LOW VOLTAGE CIRCUIT BREAKER

NO. YAMA308

Change of Indication contents in MCB, RCCB, RCBO and ISOLATOR

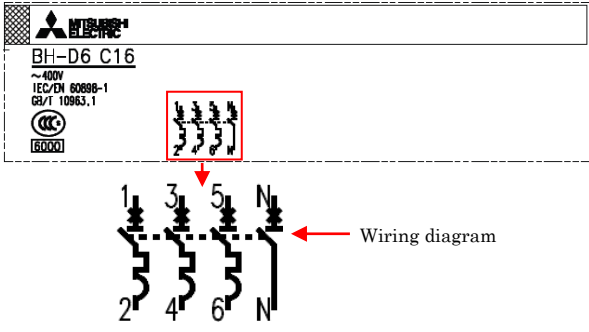
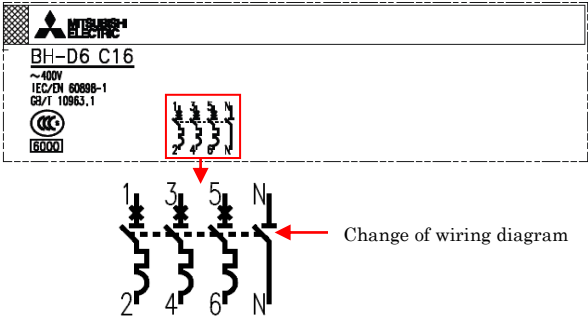
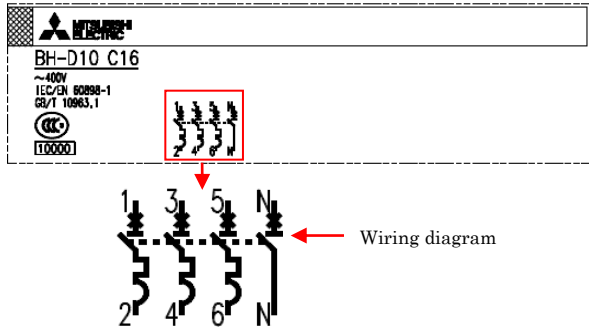
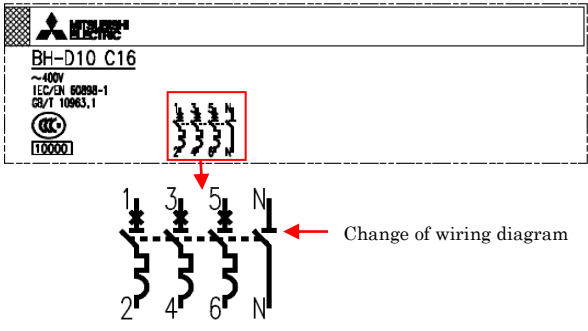
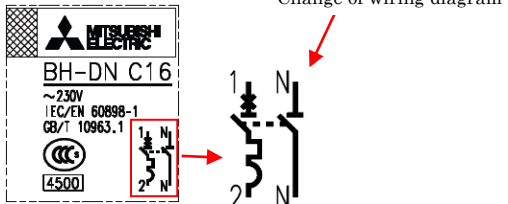
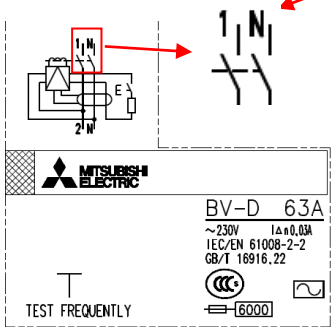
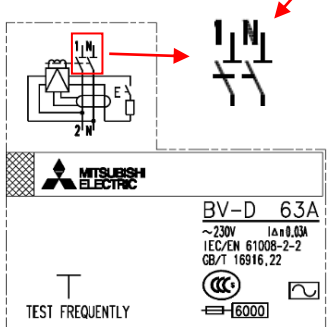
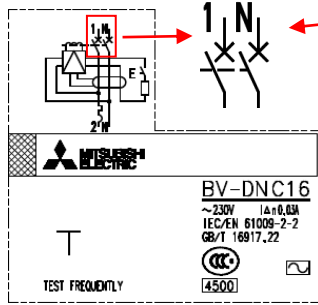
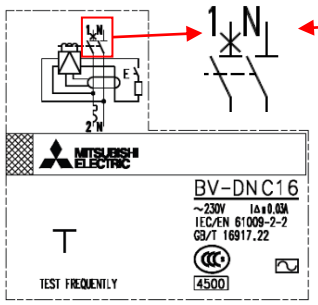
| Model | Before change | After change |
|-----------------------|--|--|
| BH-D6 4P(3P+N) | <p>Ex. BH-D6 4P 16A TYPE C</p>  <p>Wiring diagram</p> |  <p>Change of wiring diagram</p> |
| BH-D10 4P 4P(3P+N) | <p>Ex. BH-D10 4P 16A TYPE C</p>  <p>Wiring diagram</p> |  <p>Change of wiring diagram</p> |
| BH-DN | <p>Ex. BH-DN 1P+N 16A TYPE C</p>  <p>Wiring diagram</p> |  <p>Change of wiring diagram</p> |
| BV-D | <p>Ex. BV-D 2P 63A 30mA</p>  <p>Wiring diagram</p> |  <p>Change of wiring diagram</p> |
| BV-DN | <p>Ex. BV-DN 2P 16A 30mA</p>  <p>Wiring diagram</p> |  <p>Change of wiring diagram</p> |
